WISCONSIN ELECTRIC POWER CO.
POINT BEACH NUCLEAR PLANT UNIT
CUSTOMER P.O. NO.: 4500429416
FLOWSERVE CORP. S.O. D440T-1

FLOWSERVE		Flowserve Corp.	Flow Control Division	Williamsport, PA
2"-600 LB GLOBE CONTROL VALVE SOCKET ENDS, STAINLESS STEEL VALTEK MARK ONE CHANNELSTREAM WITH ADJUSTABLE PRESSURE REDUCING DEVICE				
DWN BY: RAW	DATE: 10-09-01	DRAWING TYPE	DCA	REV
CHK BY: KES	DATE: 10-12-01	914-116249		A
APD BY: MDC	DATE: 10-16-01	1 2 3 4 5 6 7 8 9

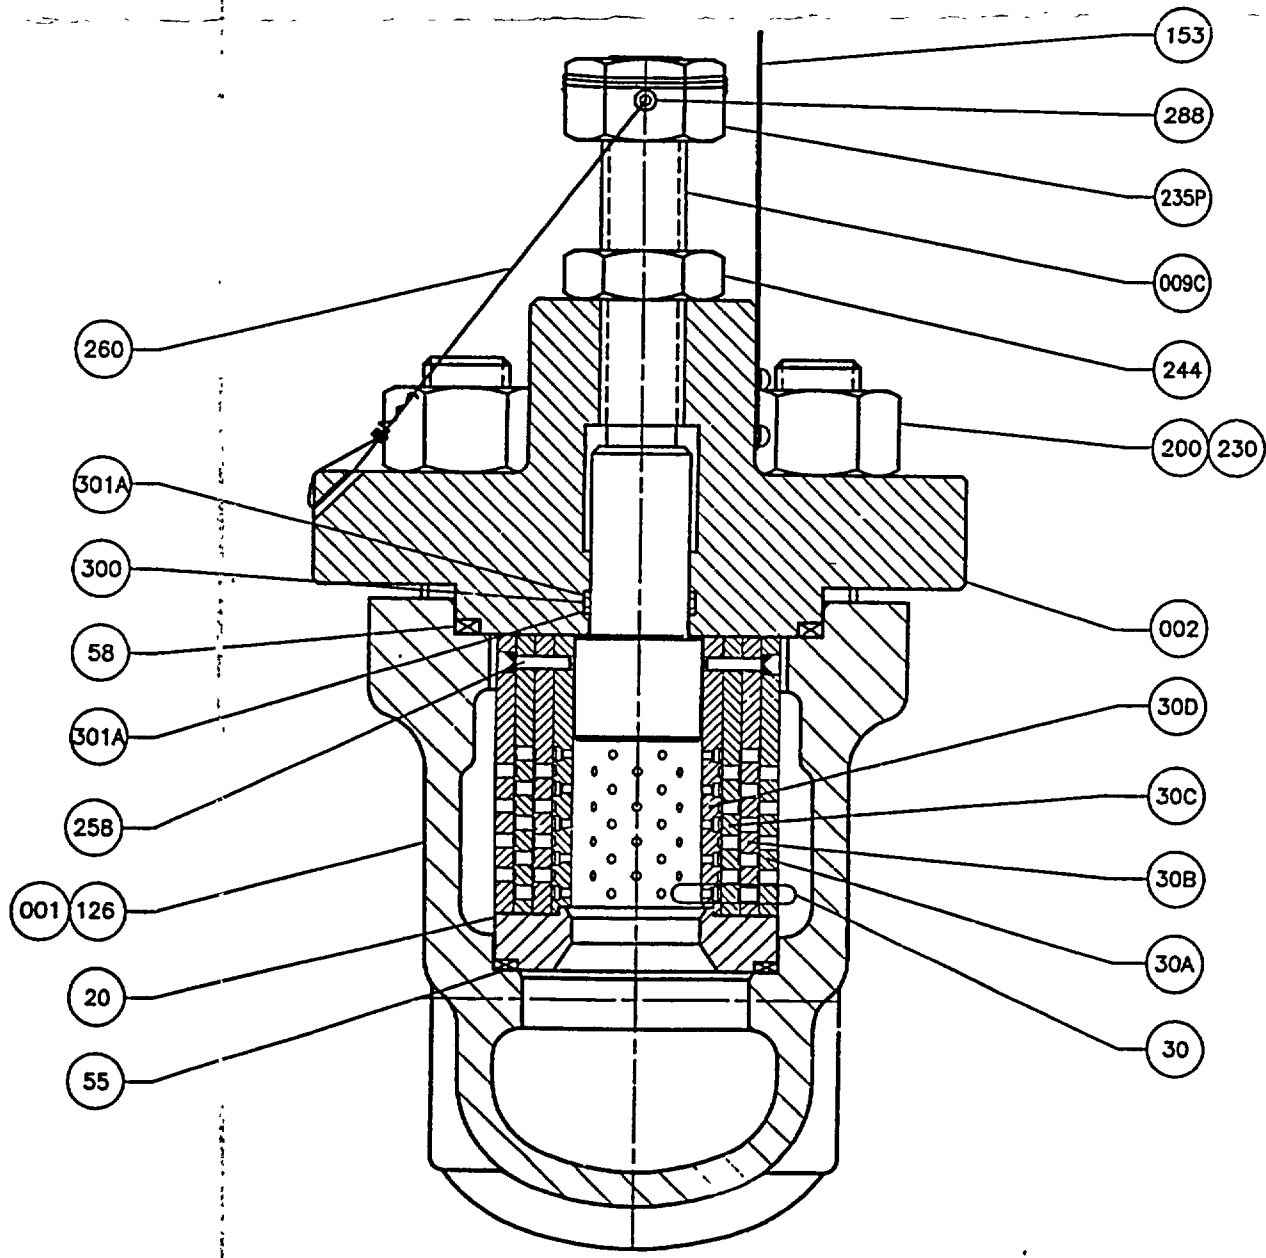
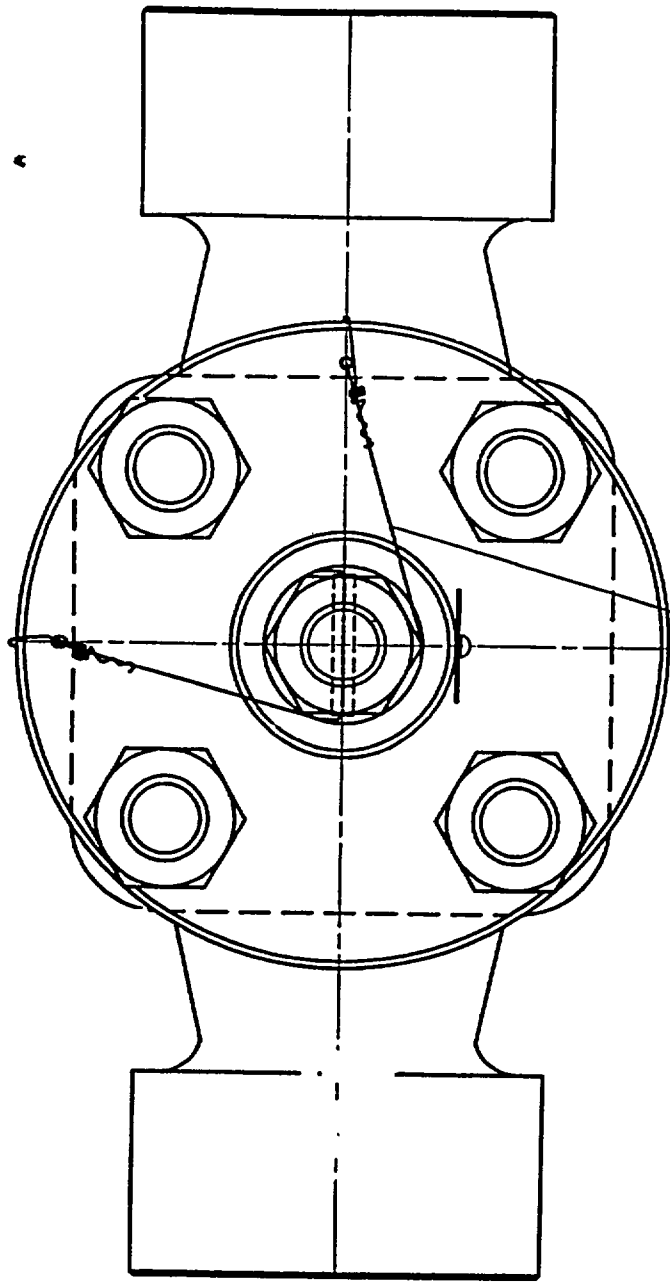
REV	REVISIONS	BY DATE	APP'D DATE
A	TOP VIEW, WIRE NOTE WAS WRAP WIRE 1 TO 3 REVOLUTIONS. ADDED PART NO'S. 153, 235P, AND 288. DELETED PART NO. 245 RETAINING RING. NOTE 3: ADDED POSITION INDICATION NO'S. 1, 2, 3, 4, AND 5. NOTE 4: ADDED SERIAL NO.: D440T-1-1	GAM 11-01

WRAP WIRE
1 TO 3 REVOLUTIONS
AFTER FEEDING THRU
HOLE IN LOCK PIN
